SERVICE BULLETIN

#0020 Revision 1

SUBJECT: Eyebolt inspection and conditional replacement

Figure 3: Type 3 Eyebolt

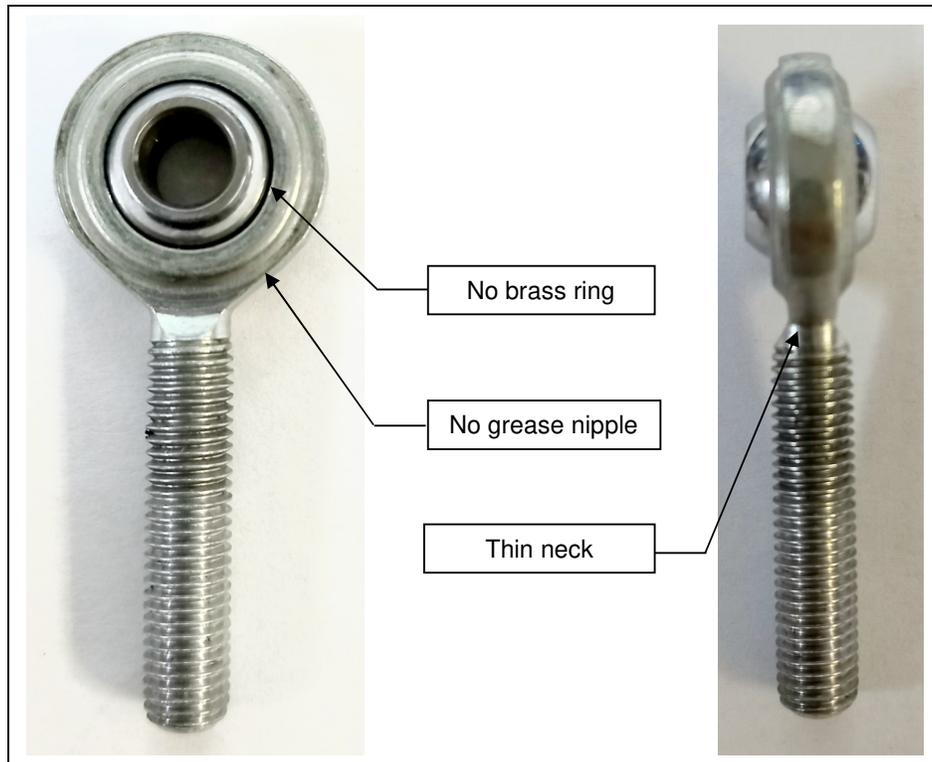
All aircraft will need to be inspected during the next MPI (or annual inspection, whichever is reached first). If it is found that *type 3* or *type 4* eyebolts have been supplied and used, they must be replaced with either *type 1* or *type 2*. Any kits still under construction will need to be inspected and required replacements must be made before the aircraft's first flight.

As seen below, the main difference between *type 3 and 4*, and the other two eyebolt types is the brass ring and shape of the neck of the eyebolt.

Figure 5: Rudder and Nose Wheel Controls

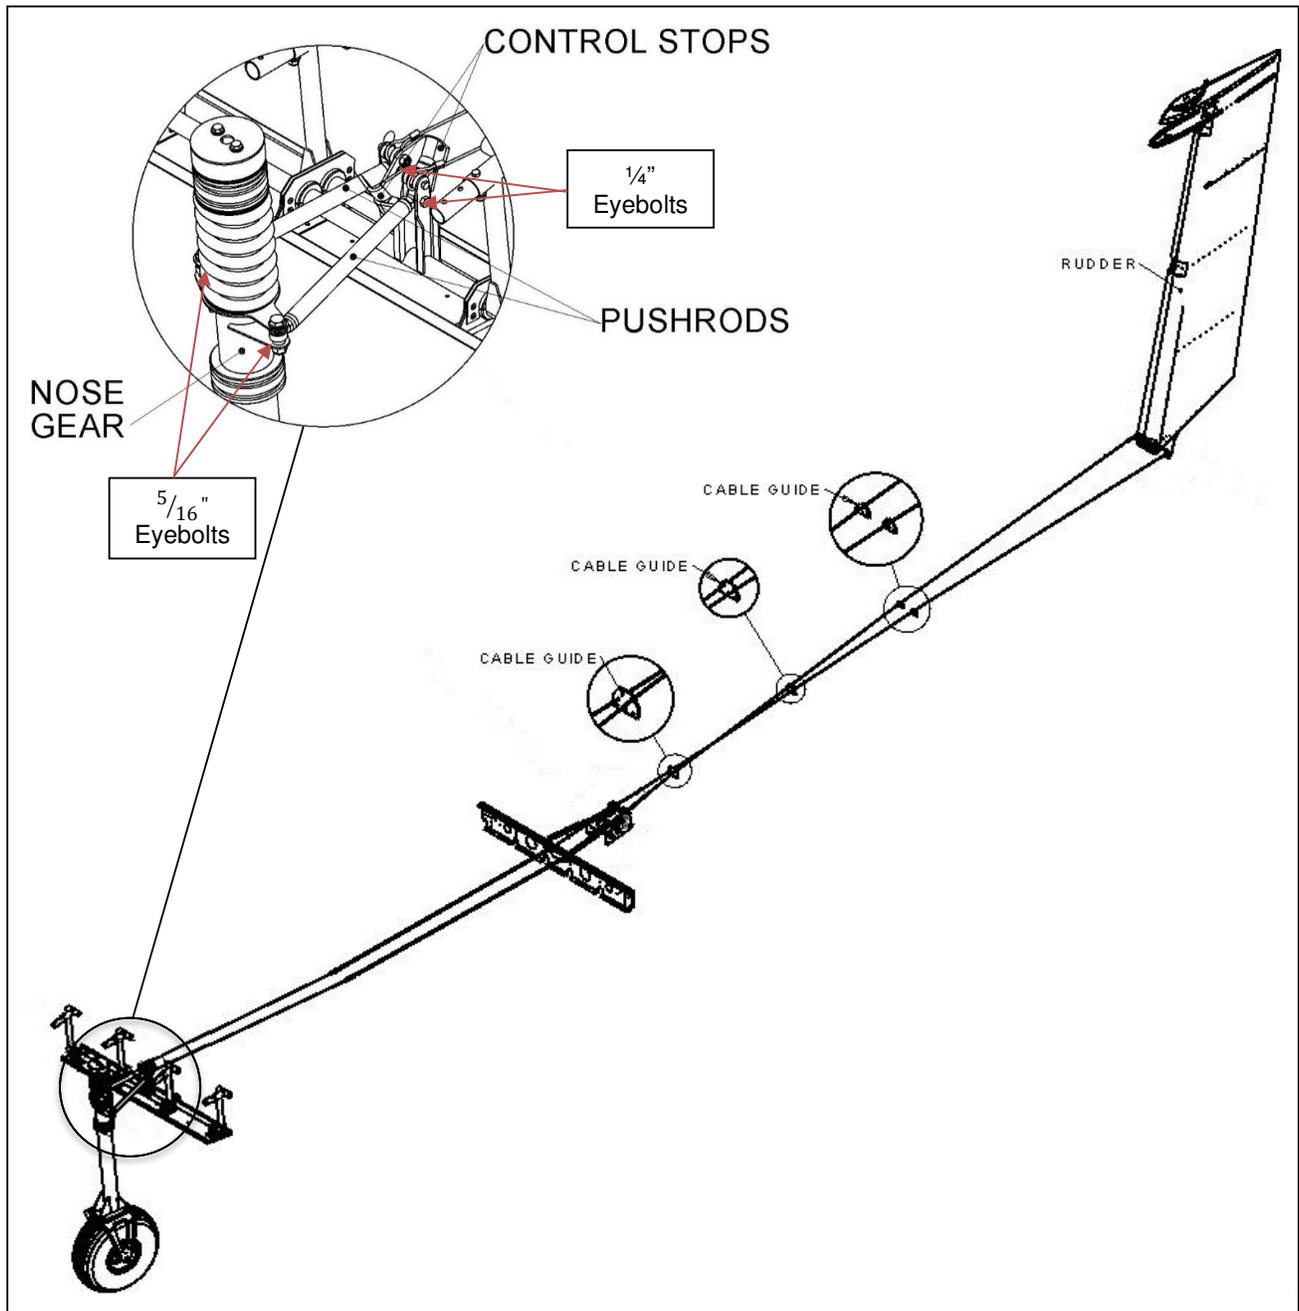
The eyebolts used in the rudder and nose wheel control arm assembly can be seen in Figure 5. The eyebolts need to be inspected and replaced where *noncompliant* eyebolts have been installed.

Step 5. Remove the 1/4" eyebolts, these are located on the rudder pedal assembly as shown in Figure 5, and can be accessed from inside the cabin. By referring to Figure 6, remove the AN4 locknut and AN4 bolt. The 1/4" eyebolt can now be uninstalled from the pushrod.

Figure 6: 1/4" eyebolt rudder pedal assembly

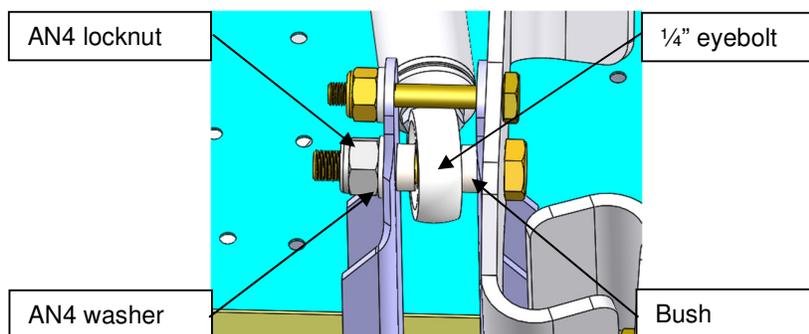
Step 6. Replace the 1/4" eyebolts with the correct type (either *type 1* or *type 2* may be used), reinstall them onto the pushrod and connect them to the rudder pedal assembly once more. Refer to Figure 6 for the way in which the components fit together.

Figure 7: Aileron Controls

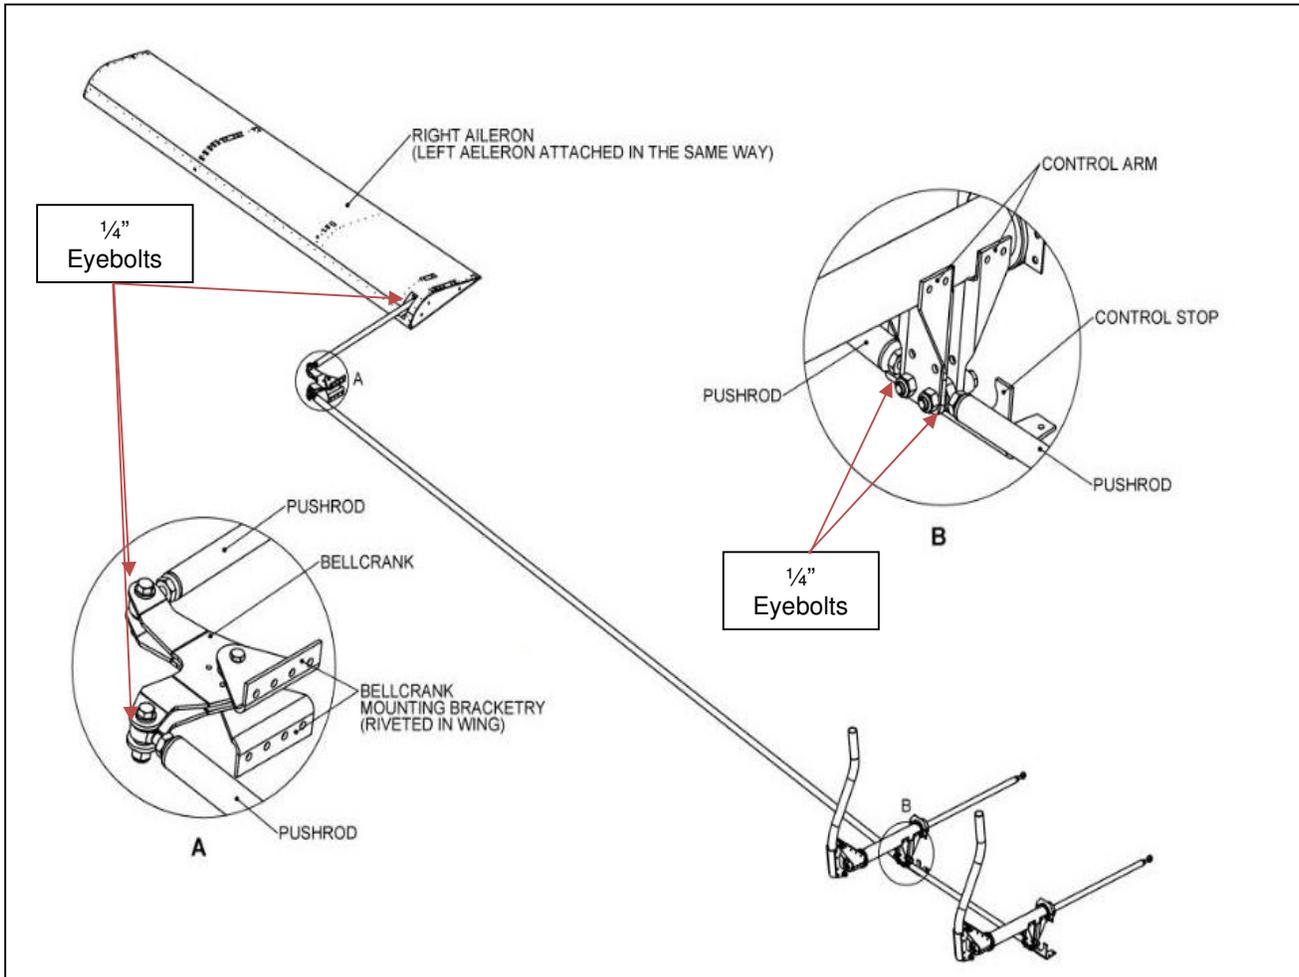
The eyebolts used in the aileron control assembly can be seen in Figure 7. These can be inspected using the inspection hatches located on the wing. Due to symmetry only one aileron has been shown. The same eyebolts will be found on the other side of the aircraft. The eyebolts need to be inspected and replaced where *noncompliant* eyebolts have been installed.

- Step 2. Ensure both eyebolts that are connected to the control arm in Detail B are replaced, with either a *type 1* or *type 2* eyebolt, if *noncompliant* eyebolts have been used.
- Step 3. Reverse the procedure in Step 1 to reinstall the eyebolt assembly.
- Step 4. To replace the eyebolts seen in Detail C of Figure 8, remove the AN4 locknut (13) and bolt (16). The eyebolt should now be uninstalled from the pushrod (5). A *type 1* or *type 2* eyebolt should then be installed on the pushrod.

Figure 8: Eyebolt assembly, Detail C

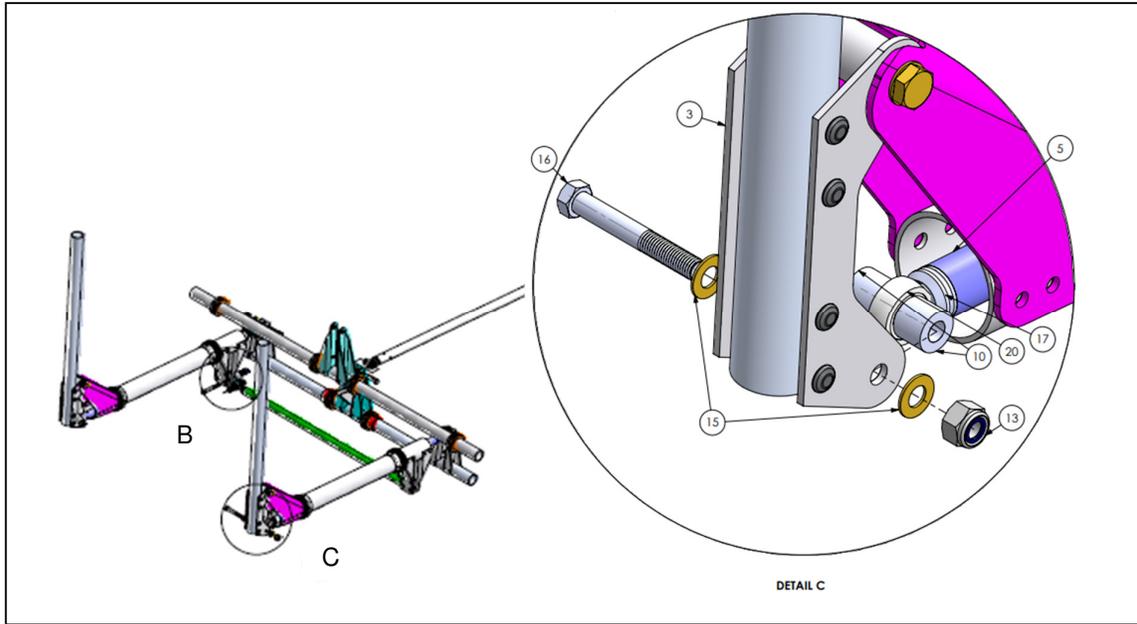
- Step 5. Reassemble the eyebolt assembly, refer to Figure 8 for component placement.
- Step 6. Repeat Step 4 and Step 5 for the same eyebolt assembly on the other side of the aircraft.
- Step 7. Do not replace the seats that were removed in Step 1 until the required eyebolts shown in Section 3.2.5 (for Sling 2 and Sling LSA) and Section 3.2.6 (for Sling 4) have been inspected and replaced, if required.
- Step 8. The eyebolts used in the aileron bell-crank also need to be inspected and replaced if *noncompliant* eyebolts have been installed. These must be replaced with either *type 1* or *type 2* eyebolts. Remove the outboard inspection hatches on both wings, to expose the bell-cranks.

Figure 9: Aileron bell-crank assembly

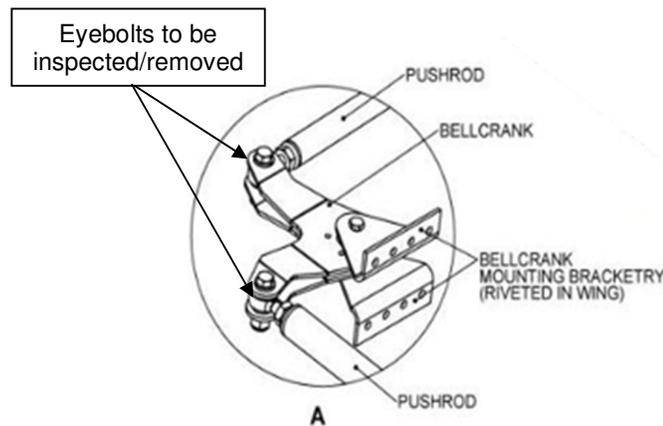
- Step 9. Refer to Figure 9 and remove the AN4 locknuts and bolts.
- Step 10. The eyebolts can now be removed and replaced with either *type 1* or *type 2* eyebolts, if required.
- Step 11. Reinstall the eyebolts to the bell-crank assembly, by reversing the procedure in Step 9 . Refer to the installation procedure in the manual shown in the table below for component placement:

Figure 10: Aileron leading edge eyebolt assembly

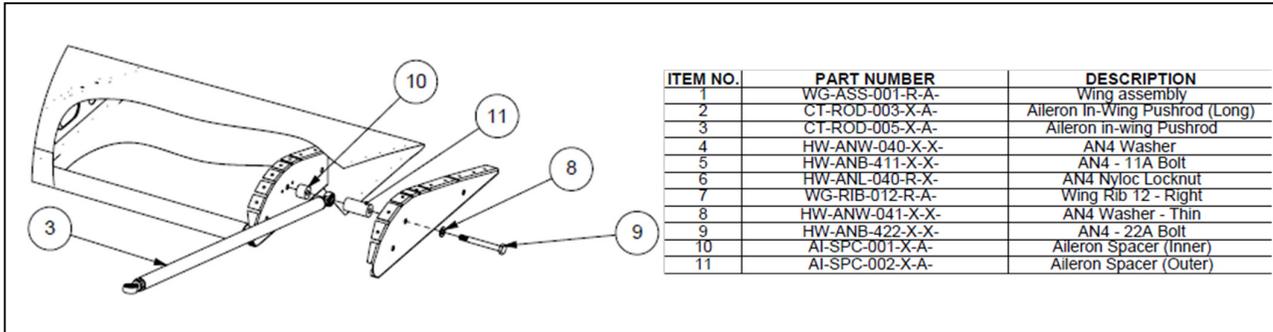
Step 13. For the eyebolts located at the ailerons leading edge, remove the AN4 bolt (9) shown in Figure 10. To access this bolt, you will need to drop the flap. To do this follow steps 1 and 2 *only*, of the flap removal procedure (Option1). This procedure can be found in the applicable MAM shown in the table below. Remember to support the flap during this step as it may drop.

- Step 14. After bolt (9) has been removed, the eyebolt can be replaced with either a *type 1* or *type 2* eyebolt. Reconnect it to the aileron and pushrod (3), as shown in Figure 10. Support the aileron during this step as it may drop once the eyebolt has been removed.
- Step 15. Reattach the flap by reversing the procedure followed in Step 13.
- Step 16. Repeat Step 9 to Step 15 to remove the eyebolts used in the aileron control assembly on the other side of the aircraft.
- Step 17. You will need to adjust the ailerons once the new eyebolts have been installed, to ensure correct aileron deflection. To do this, follow the instructions in the applicable MAM shown in the table below:

Figure 11: Aileron Controls

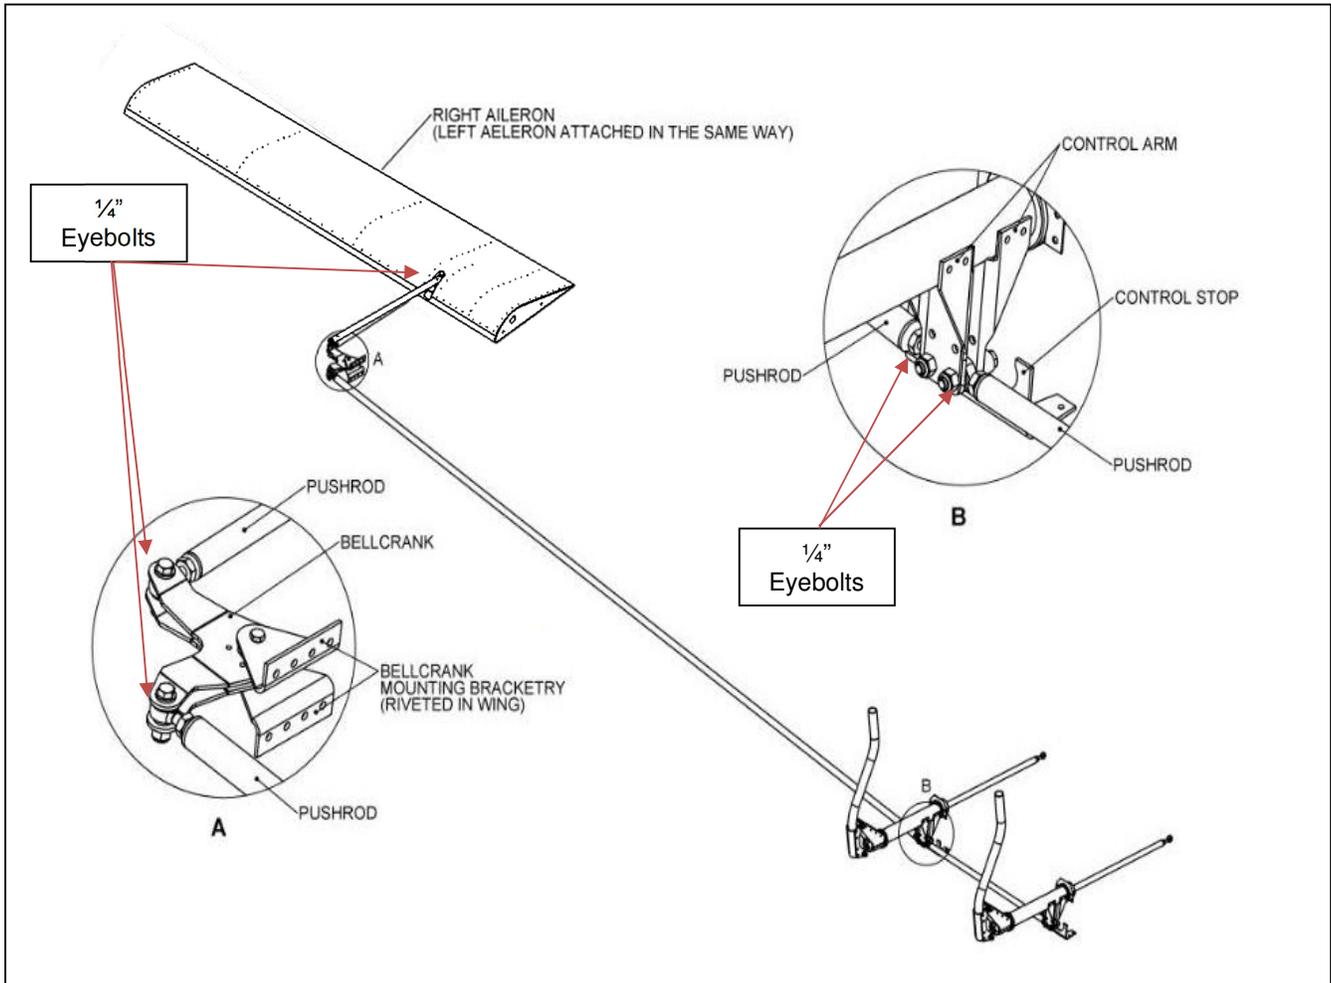
The eyebolts used in the aileron control assembly can be seen in Figure 11. These can be inspected using the inspection hatches located on the wing. Due to symmetry only one aileron has been shown. The same eyebolts will be found on the other side of the aircraft. The eyebolts need to be inspected and replaced where *noncompliant* eyebolts have been installed.

- Step 2. A *type 1* or *type 2* eyebolt should then be installed in place of the *noncompliant* eyebolt, if required. Ensure both eyebolts that are connected to the control arm in Detail B are replaced, if *noncompliant* eyebolts have been used.
- Step 3. Reverse the procedure in Step 1 to reinstall the eyebolt assembly. Do not replace the seats and control covers that were removed in Step 1 until the required eyebolts shown in Section 3.2.6 have been inspected and replaced, if required.

Figure 12: Eyebolt assembly, Detail C

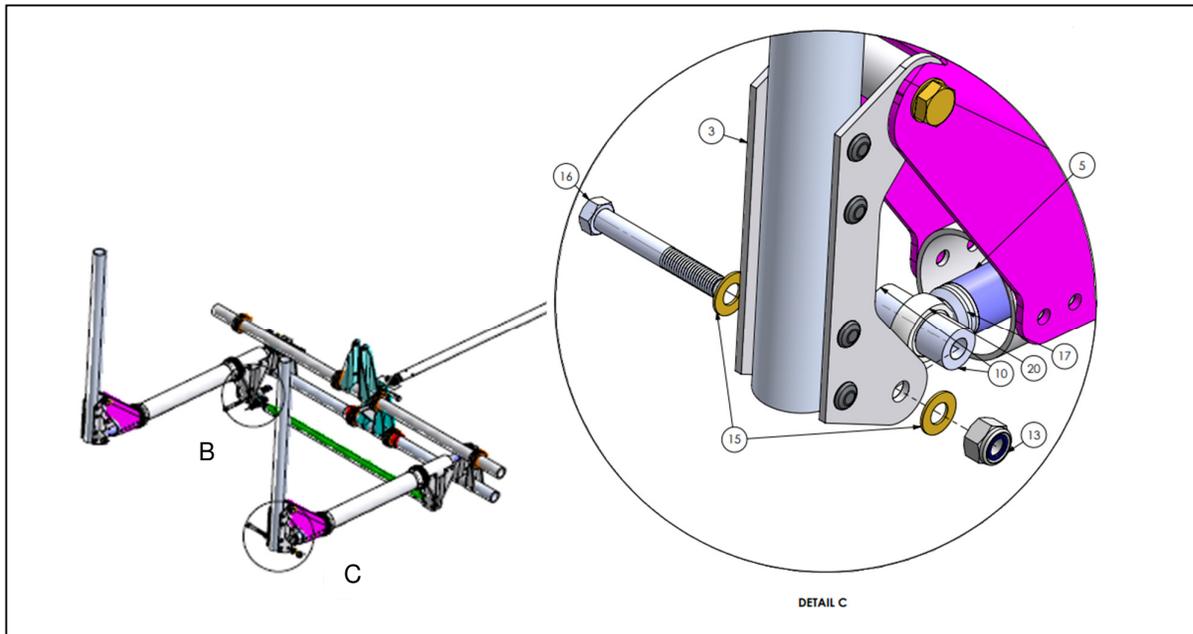
- Step 4. To replace the eyebolts seen in Detail C of Figure 12, remove the AN4 locknut (13) and bolt (16). The eyebolt should then be uninstalled from the pushrod (5). A *type 1* or *type 2* eyebolt should then be installed on the pushrod.

- Step 5. Reassemble the eyebolt assembly by reversing the procedure in Step 4, refer to Figure 12 for component placement.
- Step 6. The eyebolts used in the aileron bell-crank also need to be inspected and replaced if *noncompliant* eyebolts have been installed. These must be replaced with either *type 1* or *type 2* eyebolts. Remove the outboard inspection hatches on both wings, to expose the bell-cranks.

Figure 13: Aileron bell-crank assembly

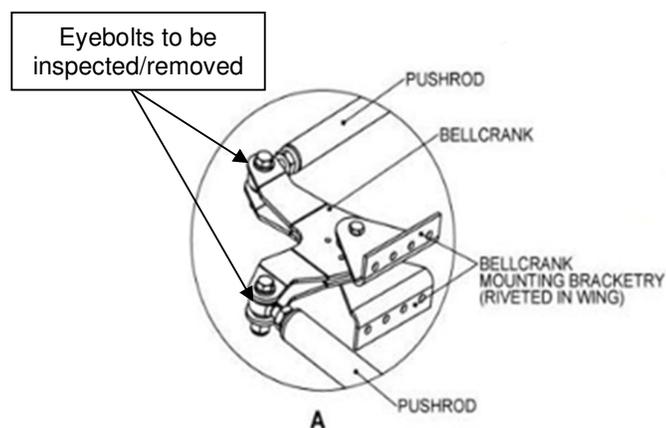
- Step 7. Refer to Figure 13 and remove the AN4 locknuts and bolts.
- Step 8. The eyebolts can now be removed and replaced with either *type 1* or *type 2* eyebolts, if required.

Figure 14: Aileron leading edge eyebolt assembly

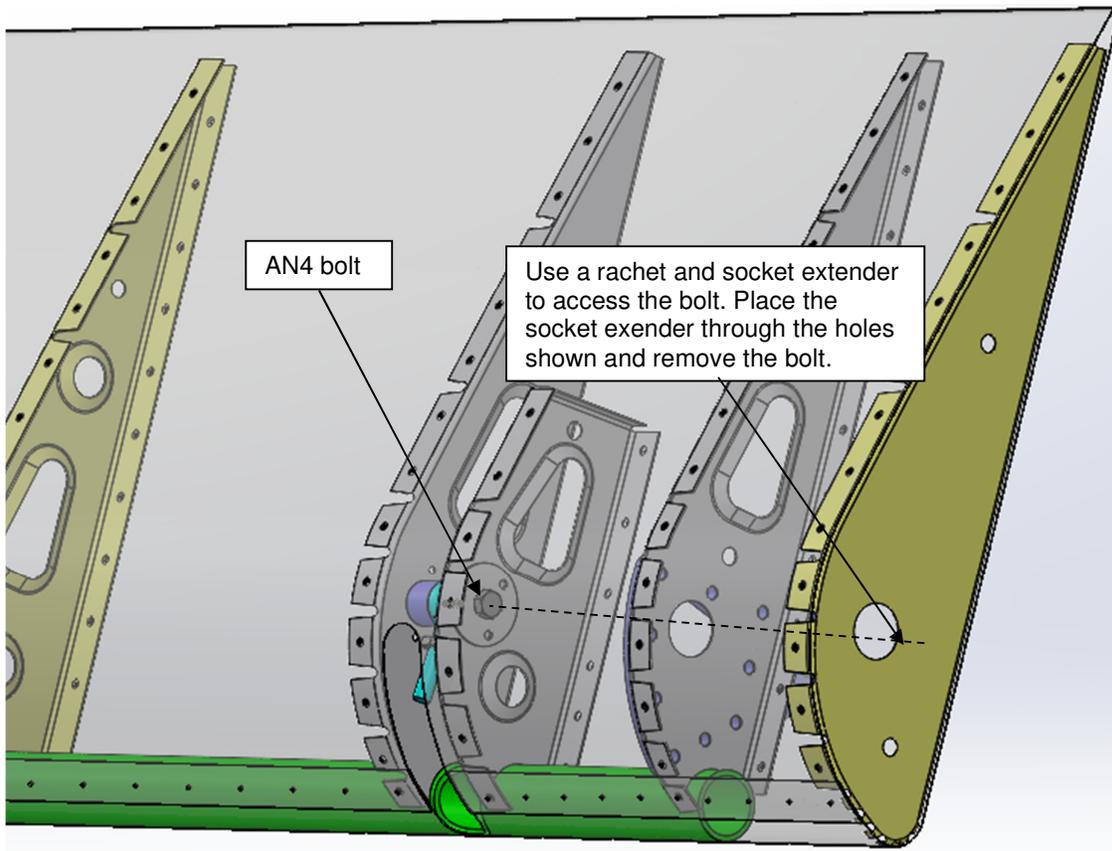
Step 11. For the eyebolts located at the ailerons leading edge, remove the AN4 bolt (9) shown in Figure 14. To access this bolt, you will need to drop the flap. To do this follow steps 1 and 2 *only*, of the Flap removal procedure (Option1). This procedure can be found in Section 4.1.3.2 of manual DC-MAM-001-X-F. Remember to support the aileron and flap during this step as they may drop.

Figure 15

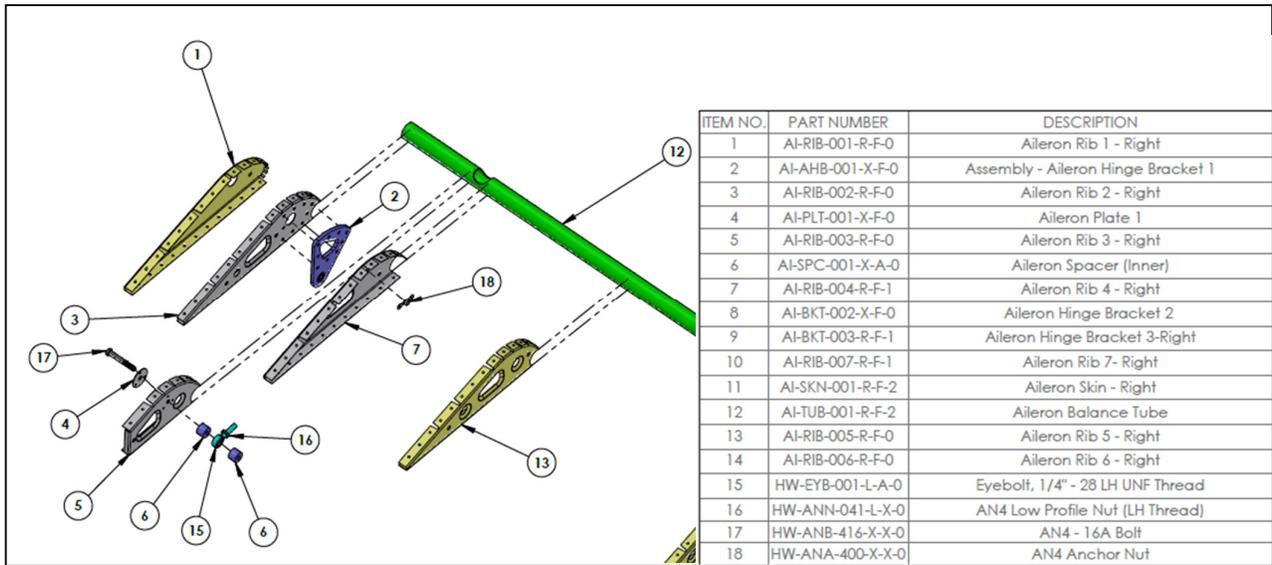
Step 12. After the bolt has been removed, the eyebolt can be replaced with either a *type 1* or *type 2* eyebolt. It should then be reconnected to the aileron and pushrod, as shown in Figure 15.
